Drawing Review

Logan Construction (SE) Response- External Fire Doors

Across the scheme there are multiple escape doors that are required to be wider than indicated on the previously submitted drawings to comply with minimum exit widths.

Figure 1.1 - Extract from Approved Planning Drawings showing West Elevation

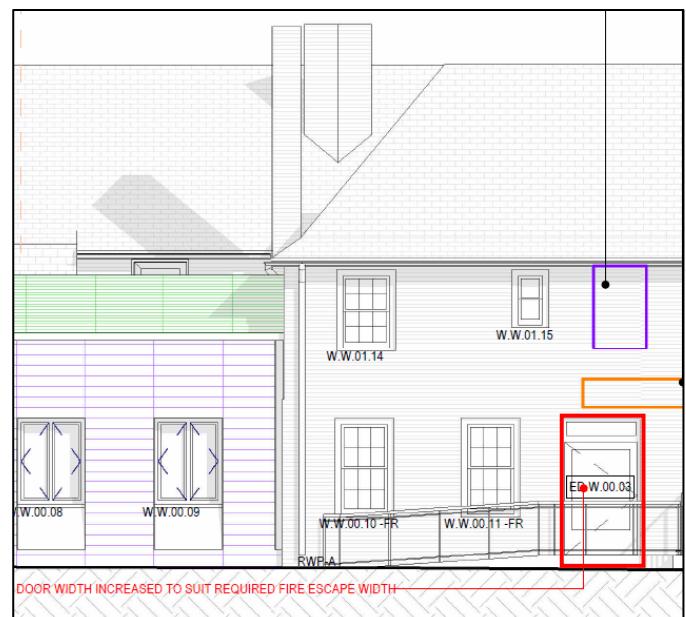
The Planning consent indicates the external escape door to ramp, as identified in *Figure 1.1 in red*.

The proposal is to increase the door width to satisfy the minimum required clear exit width. An updated Architectural proposal is shown in *Figure 1.2 in red*.
